INGRAM & ASSOCIATES
CONSULTING ENGINEERS, LLC

ADDENDUM NO. 2

April 28, 2022

**PROJECT: Repair, Overlay & Paving of Various County Roads
Peach County, Georgia
RFB 22-005
I&A Project No.: 1619-006-01**

TYPICAL SECTION

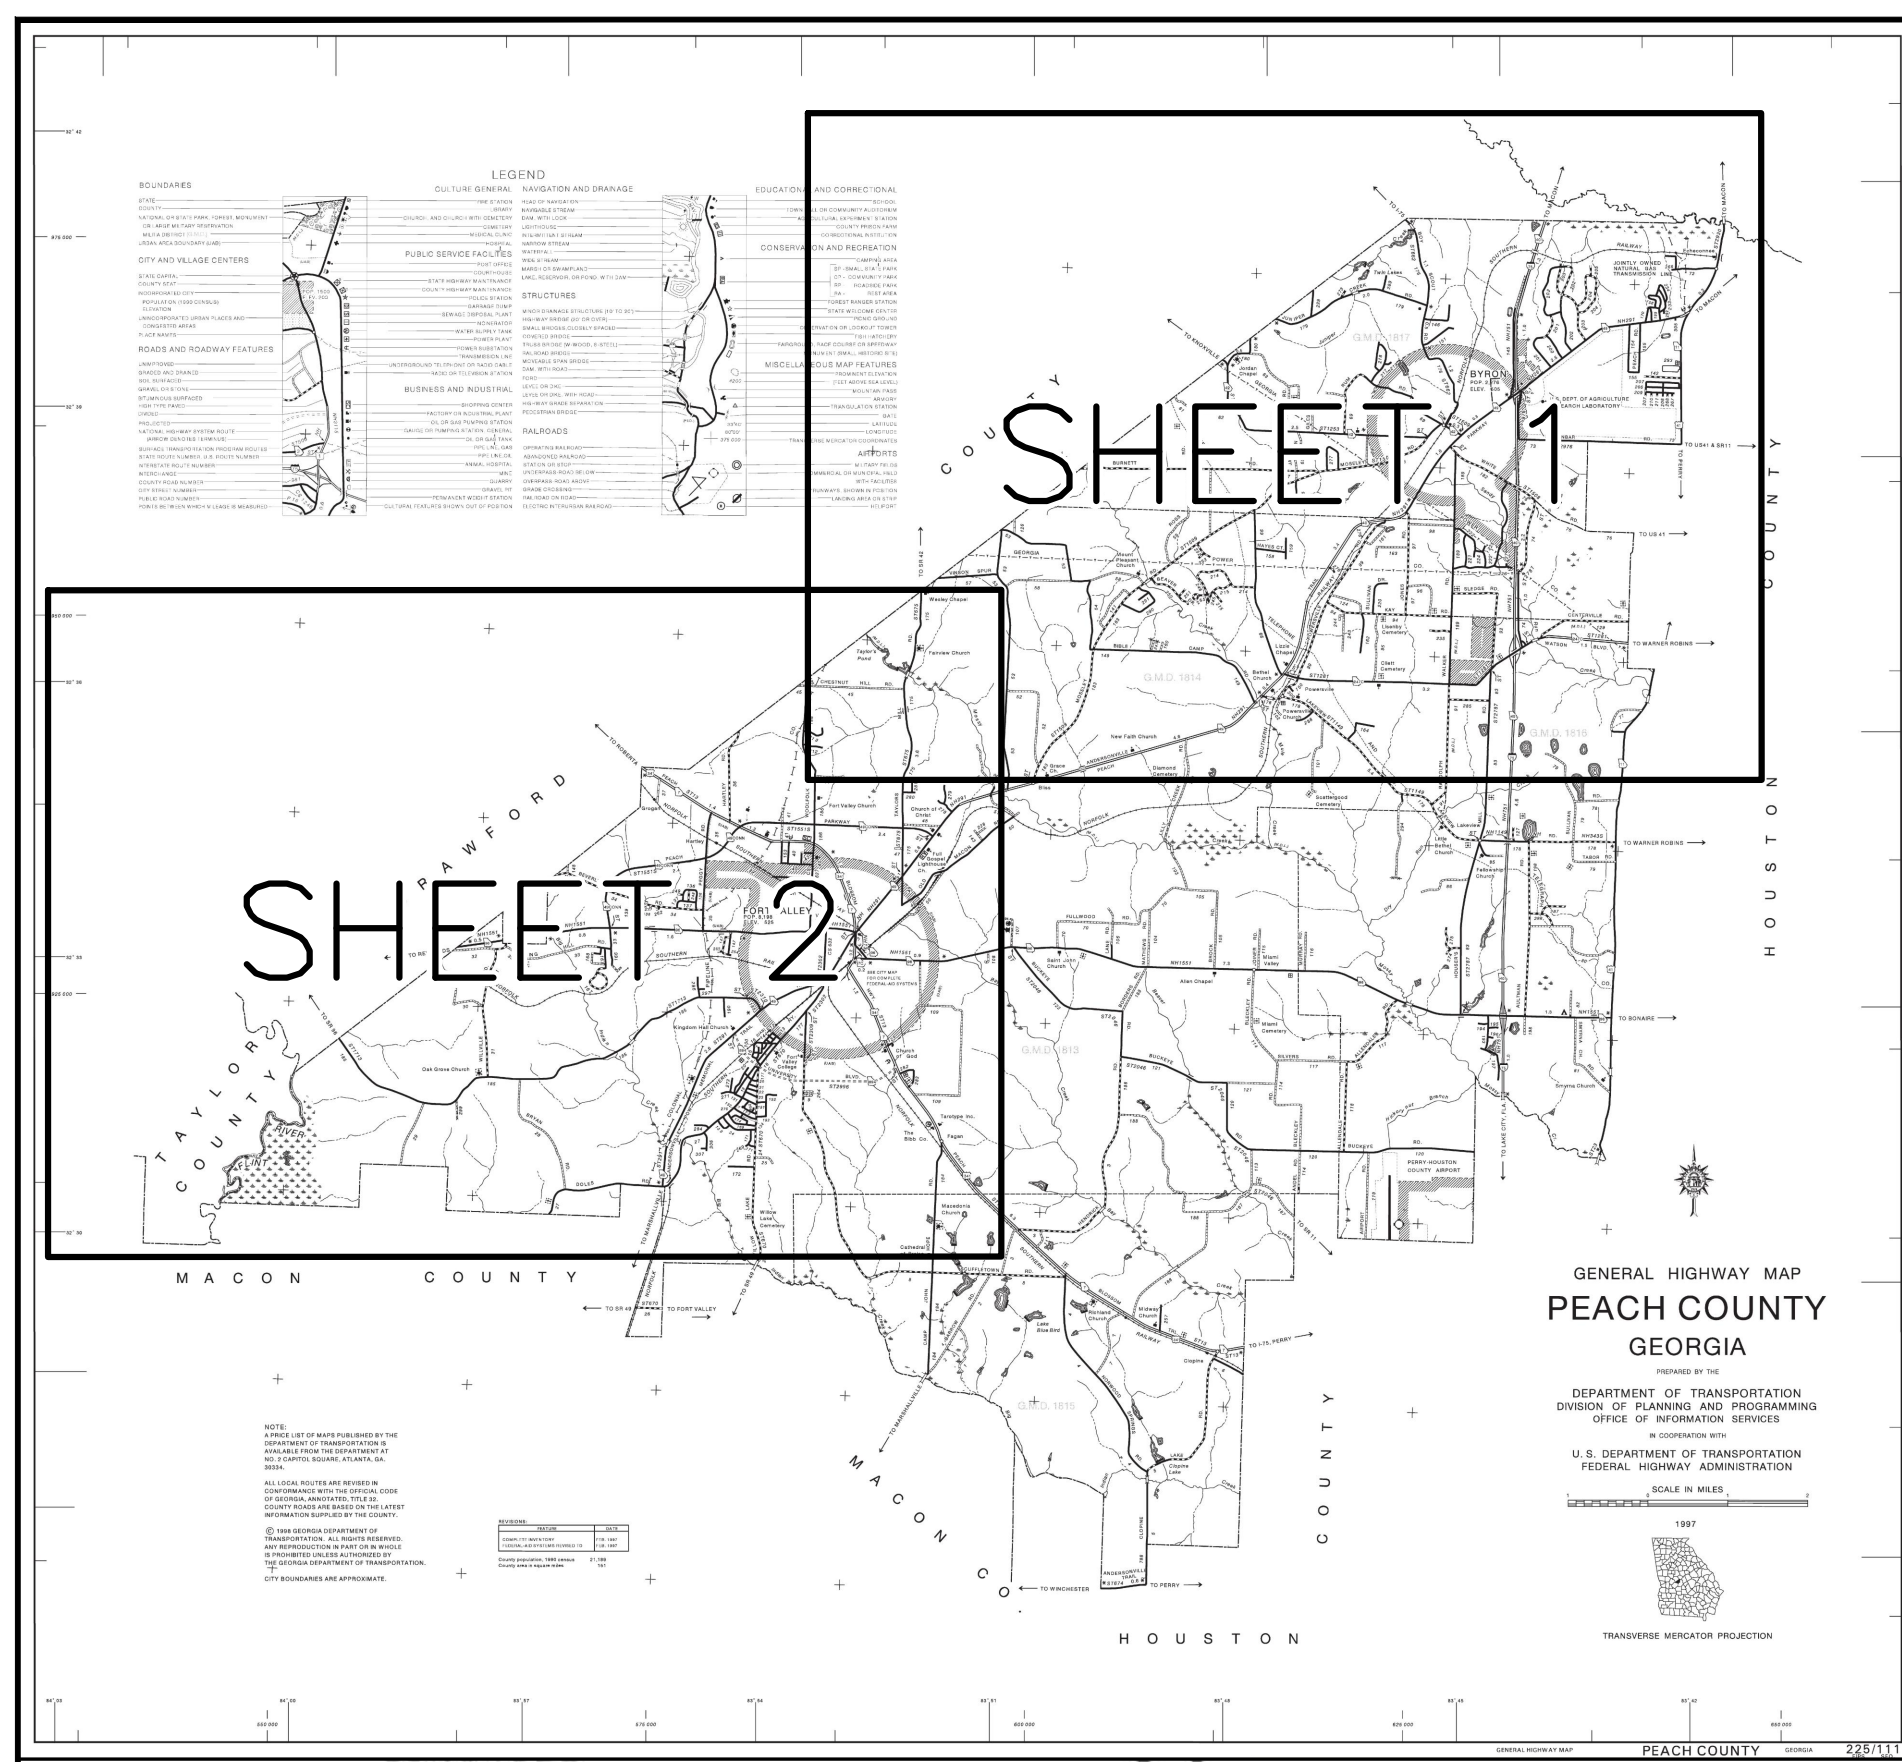
Item No. 14. Please use the revised Bid Forms attached. We have added a pay item for the project area: GDOT – Grading per mile typical. We also have included a detail for this item.

Item No. 15. Final stabilization with permanent grassing and mulching – for this item, we are looking for the contractor to hydroseed the area backfilled under grading per mile. Include all items needed to generate a permanent stand of grass.

- (1) FILL EXISTING EARTH SHOULDER AT VARIABLE DEPTH AS REQUIRED TO PROVIDE A SMOOTH GRADE FROM THE NEW EDGE OF PAVEMENT ELEVATION TYING INTO EXISTING EARTH SHOULDER.
- (2) ALL GRADING, INCLUDING ANY BORROW MATERIAL, SHALL BE INCLUDED IN PRICE BID FOR GRADING PER MILE.
